Office Action Summary	Application No. 10/673,680	Applicant(s) DOUBLER ET AL.	
	Examiner James L. Swiger	Art Unit 3733

DETAILED ACTION

FIG. 14

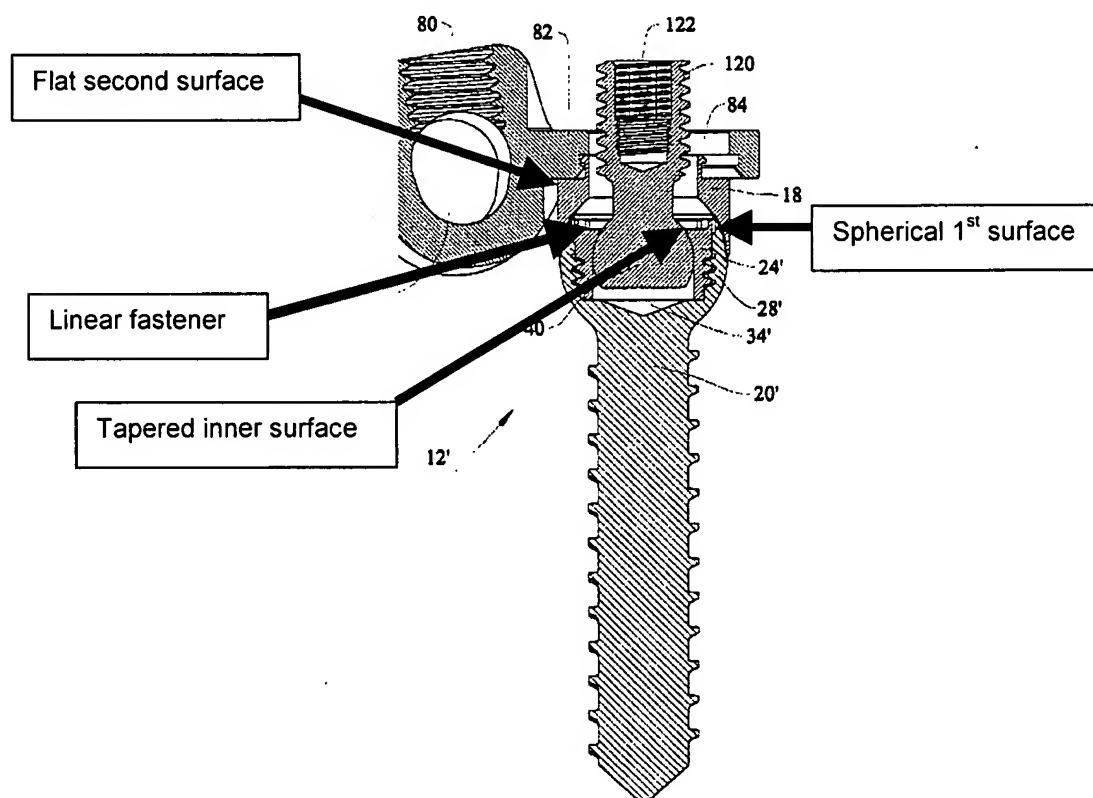
that is adapted for swivelable attachment to a linking member (Fig. 3, 32). Mullane further discloses a connecting member (82), and a portion that is capable of function as linear fastener. See Drawing of Fig. 14 below. The linear fastener also would fixedly engage about the linking member machined end to produce a clamping force.

In addition to the bone screw of Fig. 2 having a substantially spherical second end (opposite the threaded portion), Mullane also discloses a support collar (18), with a substantially spherical first surface and a generally flat second surface both of which aid in providing a clamping force for locking the linking element. See Fig. 14 above. Mullane further discloses a collet member (24') with a tapered inner

compression surface (see Fig. 14 above), and also a linking member tensioning means that has an internal bore with threads (122) that is capable being gripped by a threaded attachment to provide the necessary tensile force with respect to the collet.
